Site Accessibility Evaluation

Eastside Library
1102 E Montecito St
Santa Barbara, CA 93103
Accessibility Evaluation
Inspection Date: 08/16/2023
Inspectors: Scott Saddlemire

Report Date: 11/03/2023

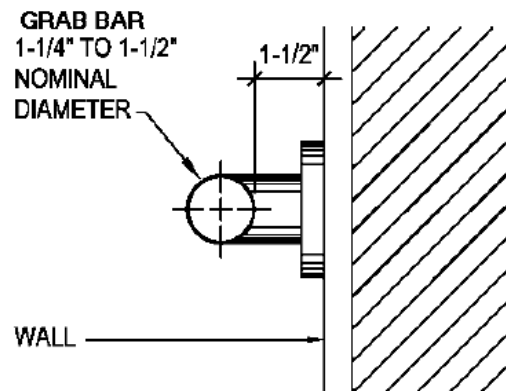
The grab bar is not correctly spaced from the wall or partition.

The diameter or width of the gripping surfaces of a grab bar shall be 1 1/4 inches to 1 1/2 inches or the shape shall provide an equivalent gripping surface. If grab bars are mounted adjacent to a wall, the space between the wall and the grab bars shall be 1 1/2 inches.

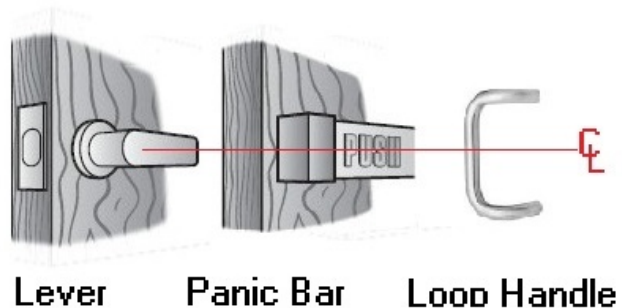
The door operating hardware is not located within the compliant range.

Hand-activated door opening hardware, handles, pulls, latches, locks, and other operating devices on accessible doors shall have a shape that is easy to grasp with one hand and does not require tight grasping, tight pinching or twisting of the wrist to operate. Hardware shall be centered between 30 inches and 44 inches above the floor.
